Core Bus Corridor 6: Lucan - Preliminary Submission

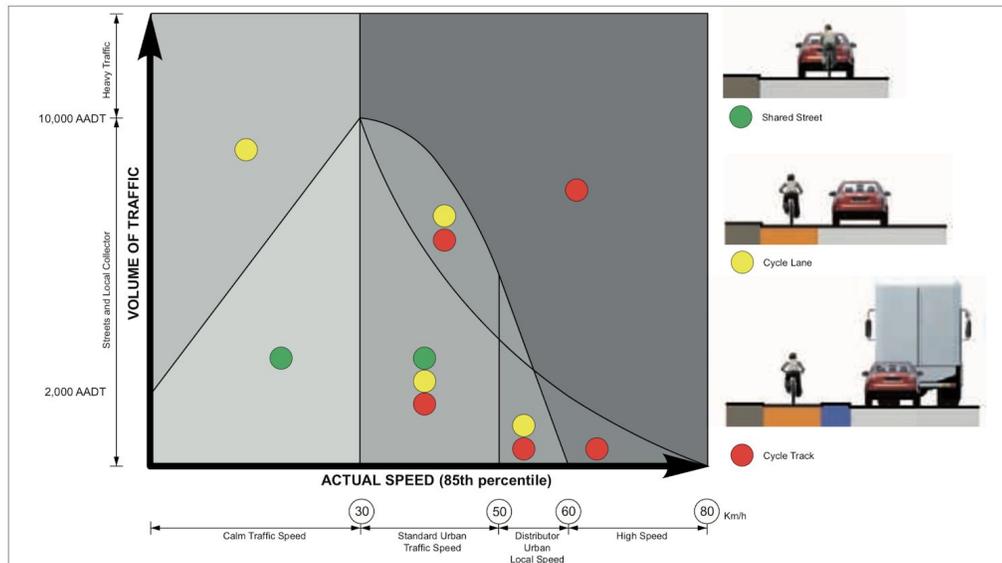
The NTA’s National Cycle Manual (NCM), section 1.7.4, requires that there is a buffer space of either a hard paved area or grass verge between the cycle track and the

roadway when the AADT and 85th percentile speeds are both high, such as the N4 or St. John's Road West.

This buffer space increases the comfort level for cyclists (one of the five needs of a cyclist). It also allows for overtaking using the full width of the cycle track, without partially overhanging the adjacent lane.

We encourage the design team to, where possible, match the design of "Cycle Track Behind Verge" on page 67 of the NCM, which has grass/planted buffer between the cycle track and the road.

There is no guidance within the NCM for the size of this buffer space (the area marked in blue in the cycle track image above). However, this design guidance from the UK maybe useful:
